AXOD/AXODE (AX4S) UPDATE HANDBOOK

INTRODUCTION

*Updated
October, 2002*

Figure 60

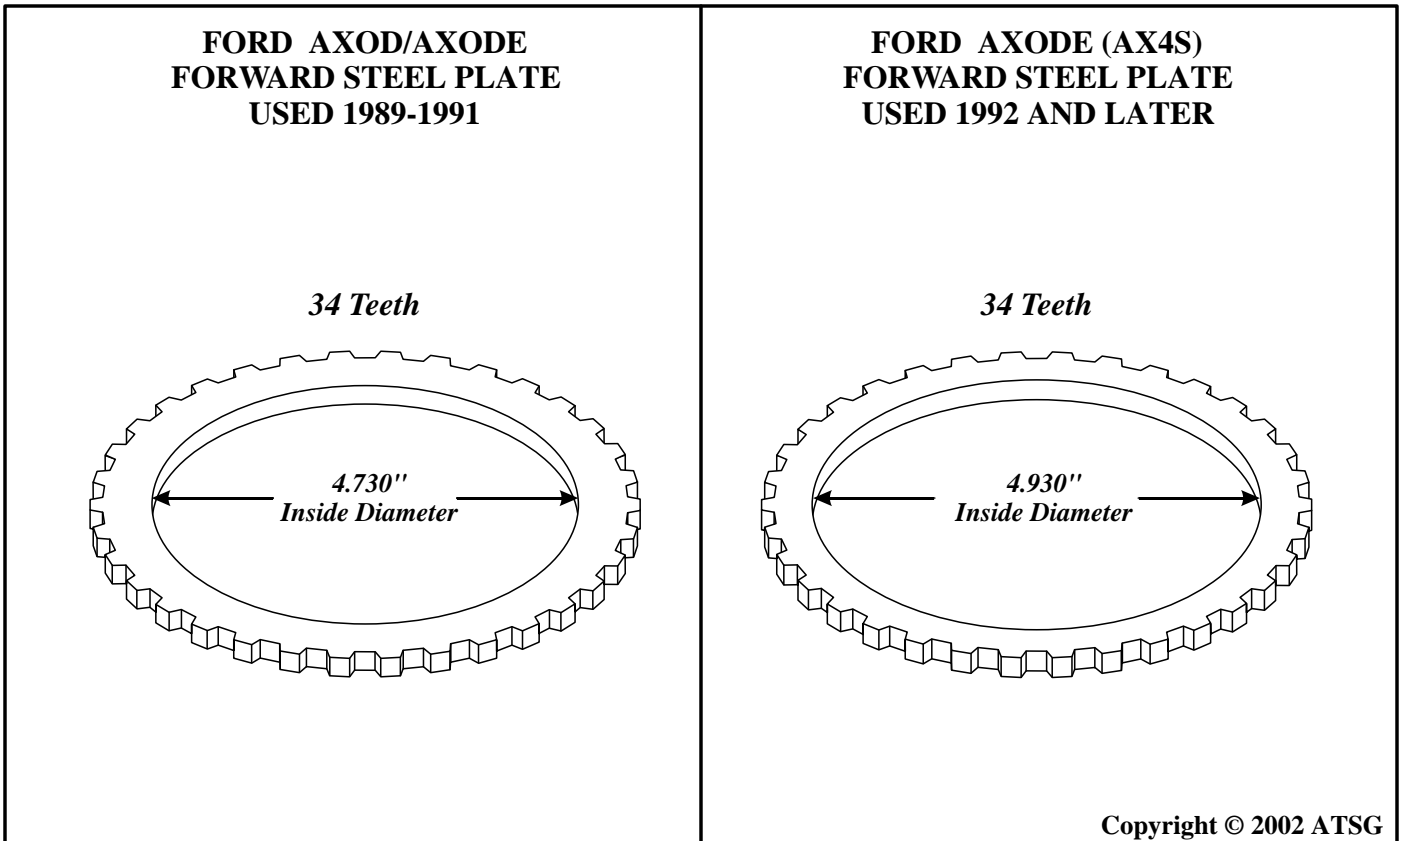
- (4) FORWARD CLUTCH PRESSURE PLATE - Has an increased inside diameter to 4.930" from the previous 4.730", to accommodate the increased diameter of the sprag outer race, as shown in Figure 60.

Figure 63

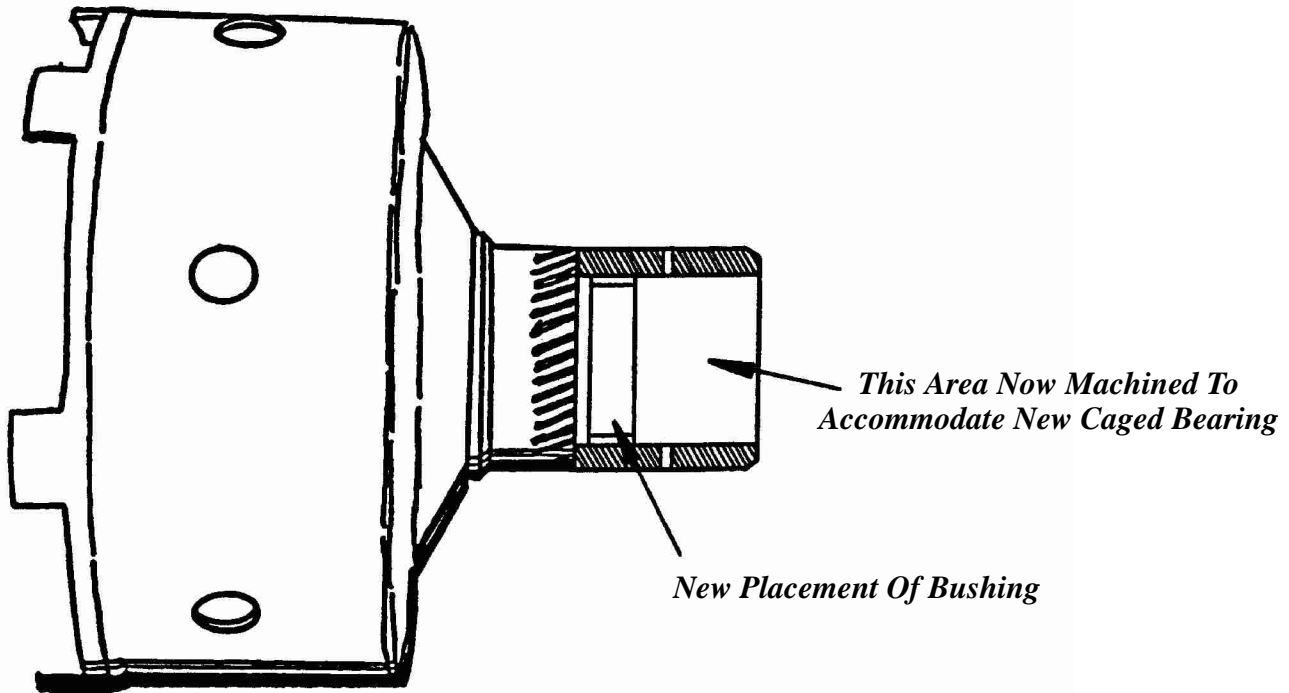
- (1) INPUT PLANETARY CARRIER - New caged needle Bearing added to the shaft on the Input Planetary Carrier, as shown in Figure 62.
- (2) SUN GEAR AND SHELL ASSEMBLY - Single bushing is now located in front of the lube holes in the sun gear, and the area behind is now machined to accommodate the new caged needle bearing, as shown in Figure 63.

Figure 75

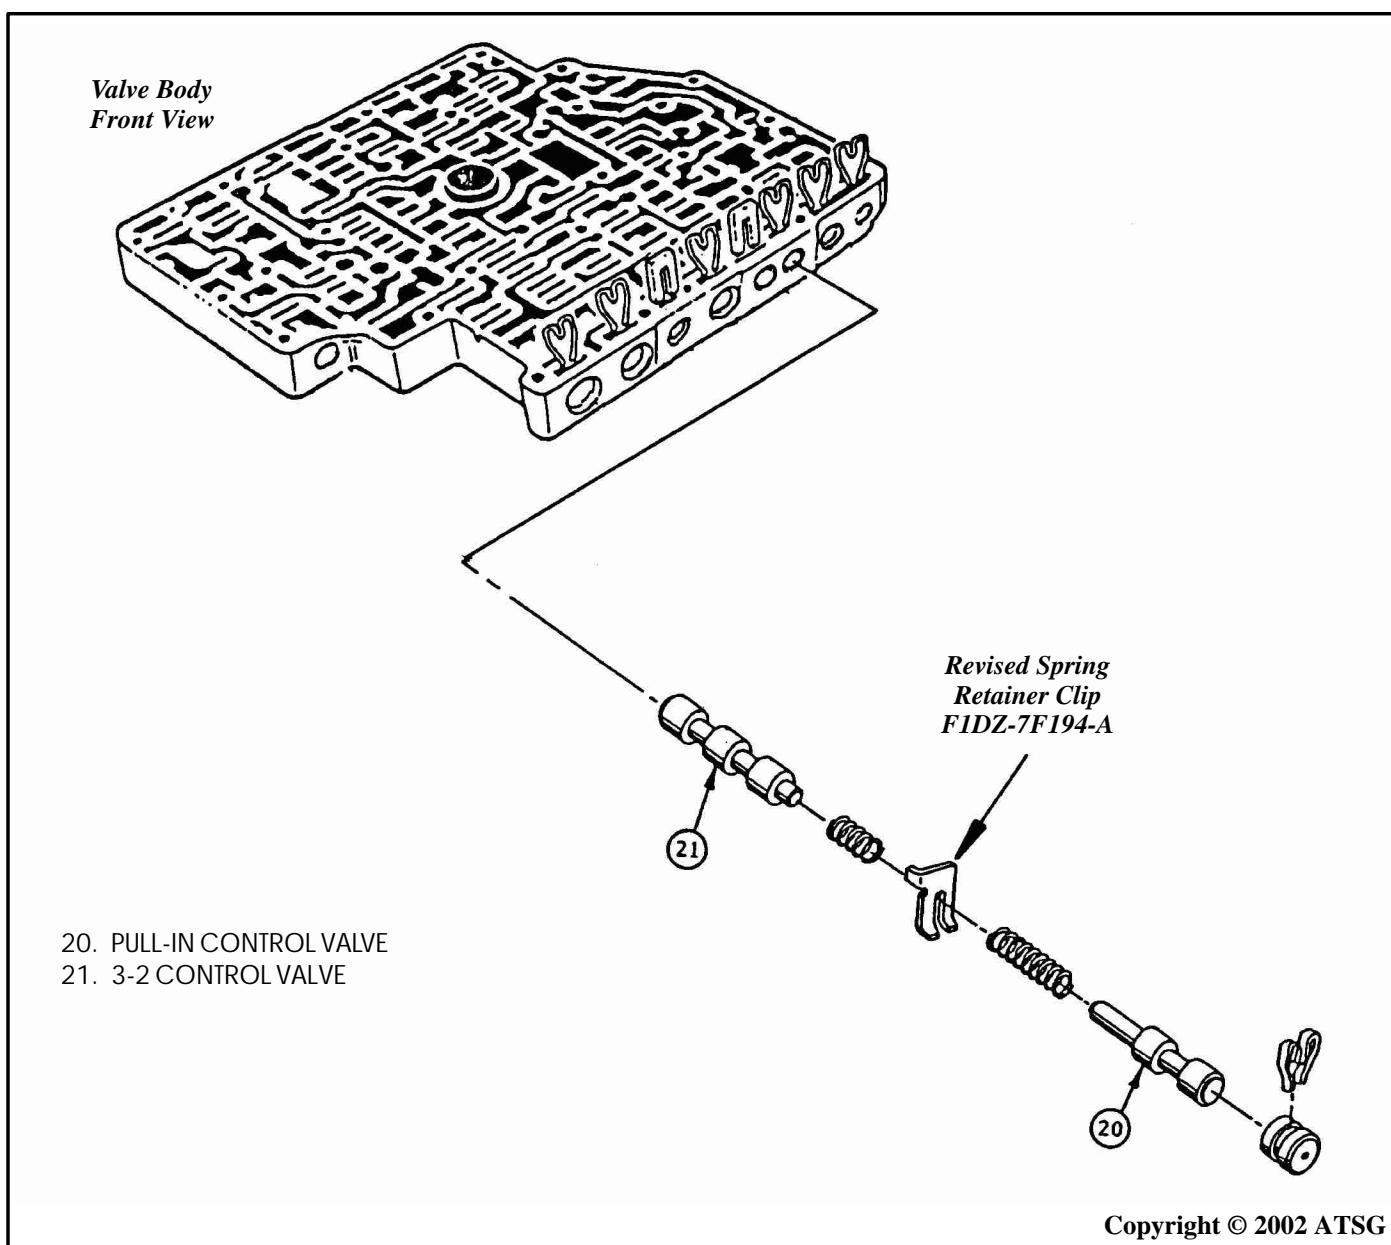
CAUSE: The cause may be, a broken spring retainer clip between the pull-in control valve spring and the 3-2 control valve spring, as shown in Figure 75.

CORRECTION: Replace the spring retainer clip with OEM part number F1DZ-7F194-A, as shown in Figure 75.

Figure 83

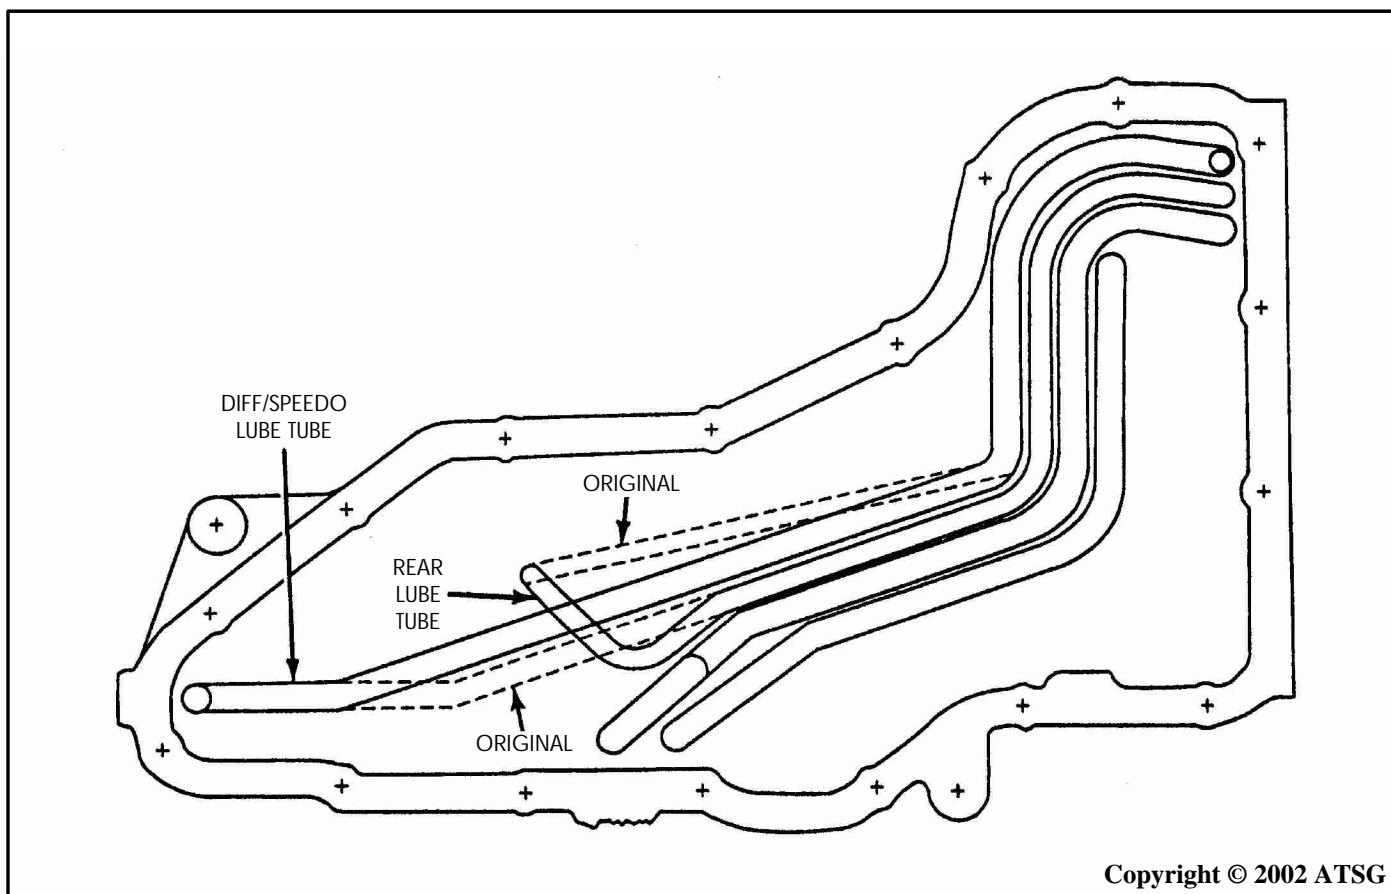
COMPLAINT: Front planetary and gear train failure with no visible root cause.

CAUSE: The cause may be, a limited volume of lube oil to the front planetary due to hydraulic control system demands.

CORRECTION: Install a new design "Cross-over" rear lube tube and a new design Differential/Speedo lube tube, that will increase the volume of lube oil to the front planetary system, as shown in Figure 83. This requires the rear lube tube to "Cross-over" the differential and speedo lube tube, as shown in Figure 83.

Figure 85

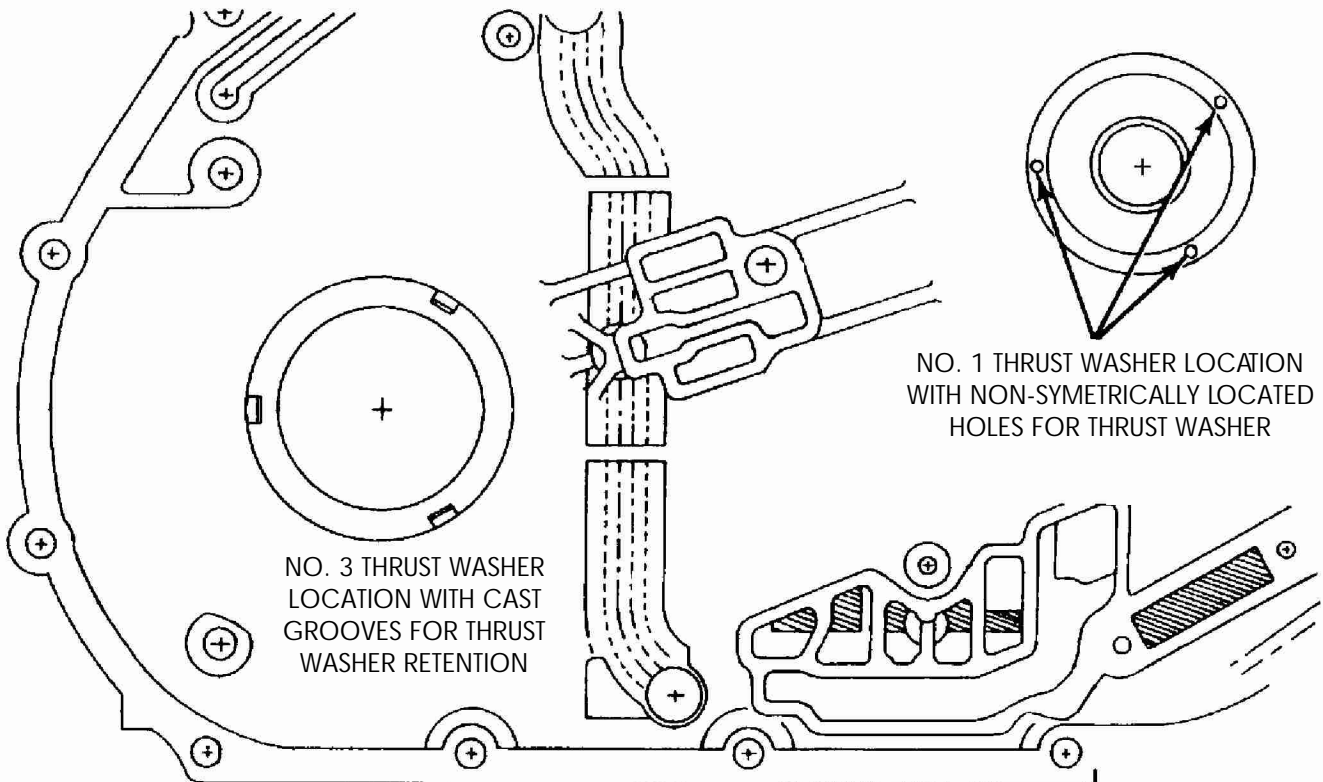
- (3) CHAIN COVER - New design will accept either the previous bronze No. 3 thrust washer with the tangs on outside diameter, or the new design Black plastic No. 3 thrust washer with the 3 symmetrically located tabs, as shown in Figure 86.
The previous design Chain Cover will accept *only* the bronze No. 3 thrust washer with the tangs on the outside diameter, as shown in Figure 85.
The new design Chain Cover will accept *only* the new design No. 1 thrust washer with 3 symmetrically located tabs, as shown in Figure 86.
The previous design Chain Cover will accept *only* the previous design No. 1 thrust washer with 3 non-symmetrically located tabs, as shown in Figure 85.

If replacement of the number 1 and/or the number 3 thrust washer becomes necessary, inspect the chain cover in the thrust washer tab areas to determine the correct thrust washers required. Refer to Figures 85 and 86.

Figure 94

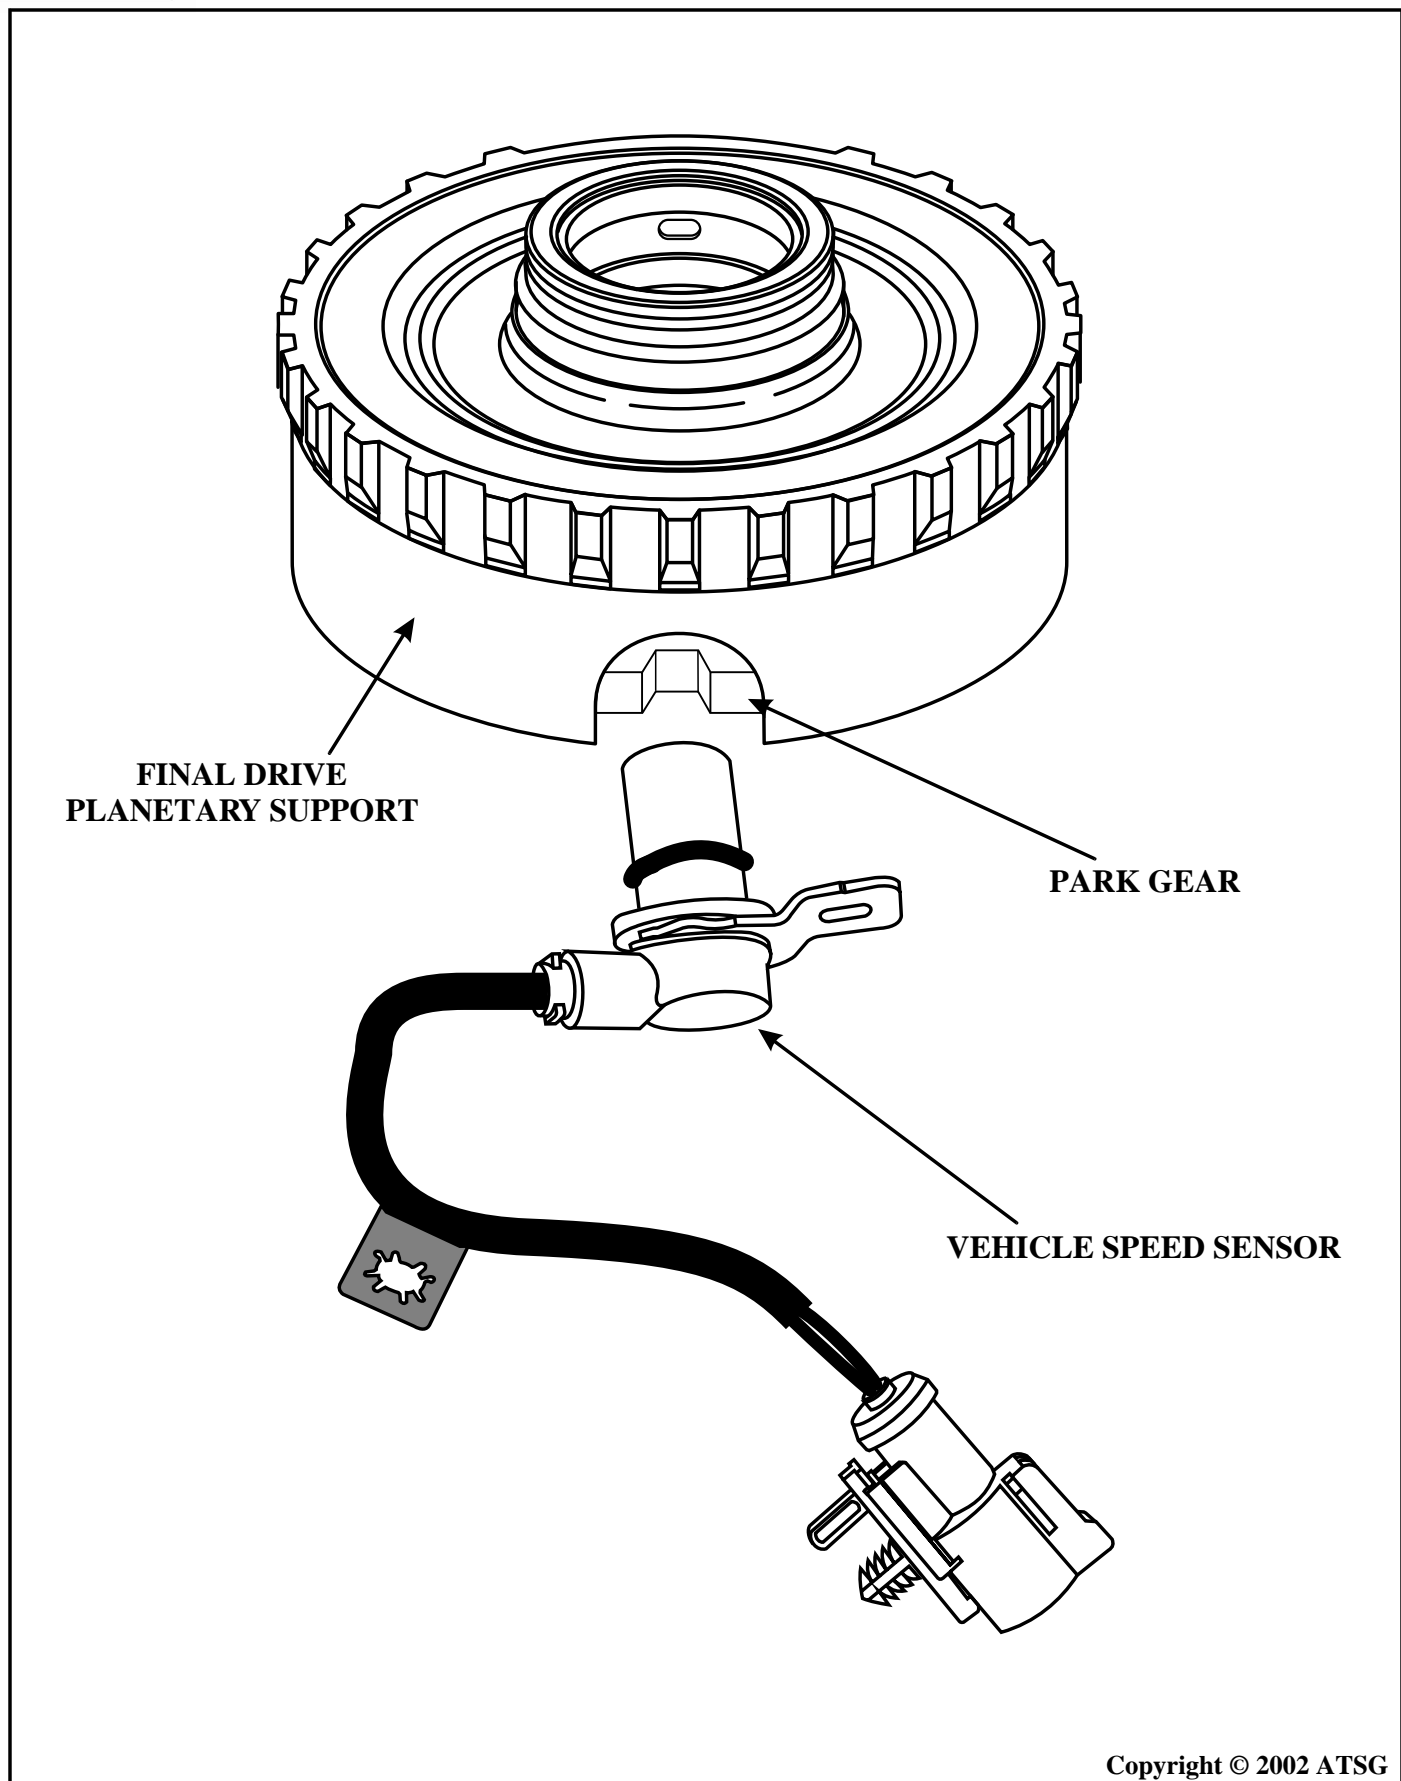
- (1) TRANSAXLE CASE - Changed to accommodate mounting the new design speed sensor so that it is in line with the planetary support and the park gear.
- (2) FINAL DRIVE SUPPORT - Changed to accommodate mounting the new design speed sensor and now has a "*cut out*" for the speed sensor to look through at the park gear, as shown in Figure 94.
